Subject: Request for more information Phase I Bond Release Application, Alton Coal Development, LLC, Coal Hollow Mine, C/025/0005, Task ID #4788

TITLE
**PHASE I BOND RELEASE
TASK #4788**

Technical Analysis and Findings

PID: C0250005
TaskID: 4788
Mine Name: COAL HOLLOW
Title: PHASE I BOND RELEASE

PROJECT Coal Hollow MINE Alton Coal Development Ref. C/025/005 FIGURE **A**

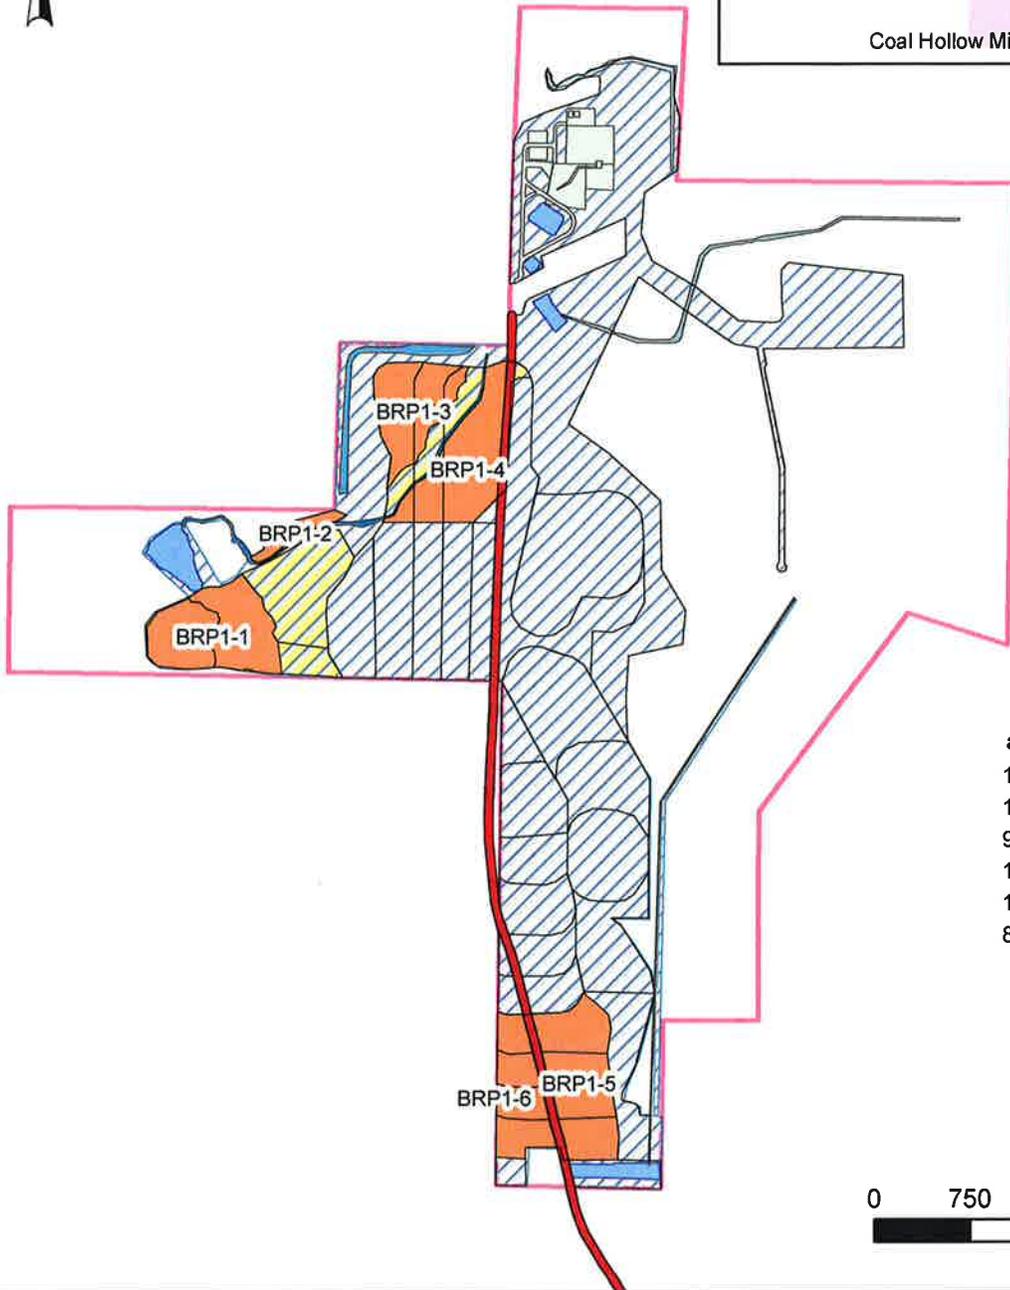
- The area detailed as BRP1-2 on Figure 1 within the application contains the sections of Ditch 4. The application includes a requested release of 2.1 acres for said area, however, Ditch 4 is scheduled to be removed after reclamation therefore the area is not at final grade. The section of BRP1-2 that contains Ditch 4 does not meet the requirements of R645-301-553 for phase I bond release and will be surveyed and flagged by the Permittee to determine the new area, see Division Figure A.

for phase I bond release and the area associated with the Lower Robinson Reconstruct will need to be surveyed and flagged by the Permittee to determine the area needing to be removed from the application. The Division estimates that the survey will likely result in changing the area associated with BRP1-3 to approximately 9 acres, see Division Figure A.

- Ditch 4 is also currently in the process of being reconstructed as designed in the MRP and the area associated with the ditch location will also need to be removed from the original BRP1-3 area thus creating a new area detailed BRP1-4 on Figure A totaling 12.1 acres. The section of BRP1-3 that contains Ditch 4 does not meet the requirements of R645-301-553 for phase I bond release and will be surveyed and flagged by the Permittee to determine the new area, see Division Figure A.

- BRP1-4 and BRP1-5, as detailed on Division Figure A, intersect with the Kane County road. According to the agreement outlined in the MRP Appendix 1-7, approval from Kane County DOT is required to include the areas as final grading. Until documentation showing that the area meets the Counties requirements, BRP1-4 in the application Figure 1 will be divided to exclude the County road from each edge of right away and be labeled BRP1-5 and BRP1-6, as shown on Division Figure A.

In conclusion, the Permittee will conduct surveys and flag the area described above and deliver to the Division the necessary documentation and new bond release acreage.
